**No.** 2006-05(W)

**MODELS:** 2004–2007 Model Year 40–90 HP  
Evinrude® E-TEC® Outboards

**SUBJECT:** Fuel Filter Replacement

TYPICAL (90 HP shown)

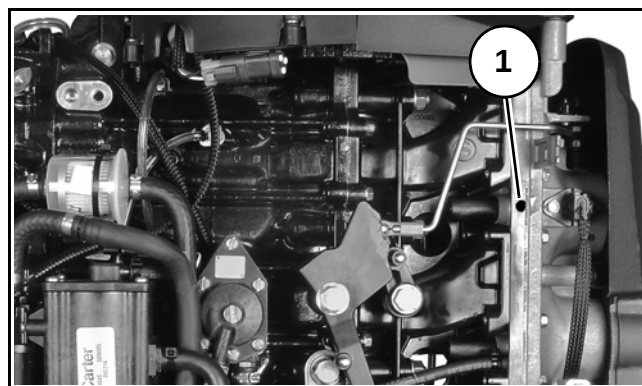
Remove the engine cover and inspect fuel filter and adjacent areas for any indication of leaking fuel. Look for mark as shown below. If the mark is present the fuel filter has been replaced. If **NO** mark is present replace original fuel filter with new fuel filter kit, P/N 5007335.

1. Mark

Shipping carton mark indicates fuel filter replacement was performed at factory.

1. Green mark

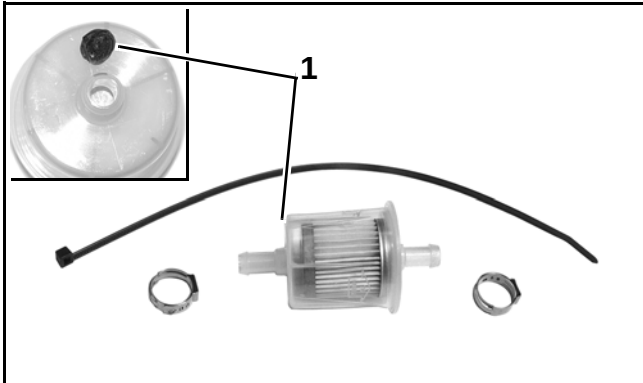
Order replacement fuel filter kit, P/N 5007335. New filters are marked as shown below.

1. Mark

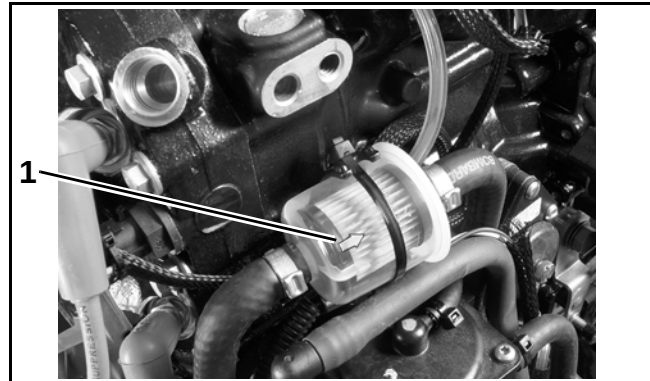
Position filter in fuel supply hoses. Note arrow indicating direction of fuel flow. Secure filter with appropriate clamps. Clamps must be secured using Oetiker® pliers, P/N 350860.

Install tie strap to position filter as shown. **DO NOT** overtighten tie strap as to deform filter housing.

1. Arrow

TYPICAL (90 HP shown)

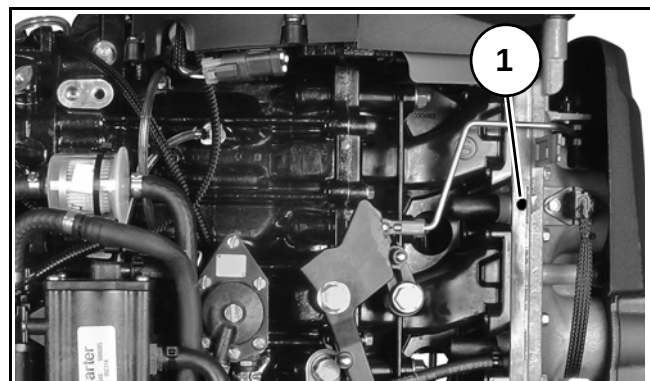
Outboards with replacement fuel filters must be easily identified.

Use a BLACK permanent marker to mark the reed plate adjacent to the air temperature sensor.

1. Mark
